21ST CENTURY TECHNOLOGIES

Steven L. Baggett
Section Chief
U.S. Nuclear Regulatory Commission
Sealed Source Safety Section
Division of Industrial and Medical Nuclear Safety
Washington, D.C. 20555

I have read over the registration certificate and have discovered an error on my part with regard to Series 100 and Series 500 sight configurations. The wall thickness on Series 100 is listed as a minimum of .018" but should be listed as .010". The wall thickness of Series 500 is listed as a minimum of .020" but should be also listed as .010". I have included prints noting these changes.

SERIES 100

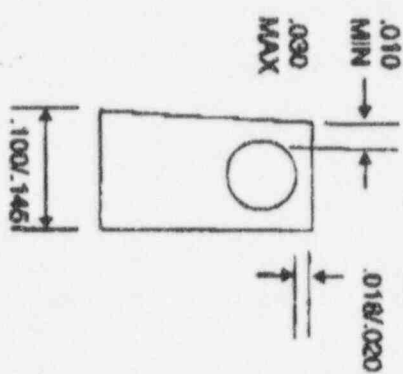
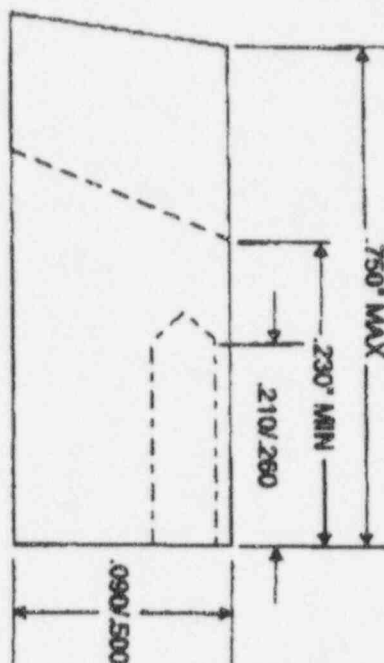
All previous testing and evaluation was performed using the .010" wall in Series 100 and the Series 500 sight and we therefore respectfully request these changes be reflected on the new certificate. The .018" figure was incorrectly transcribed and should read as .010".
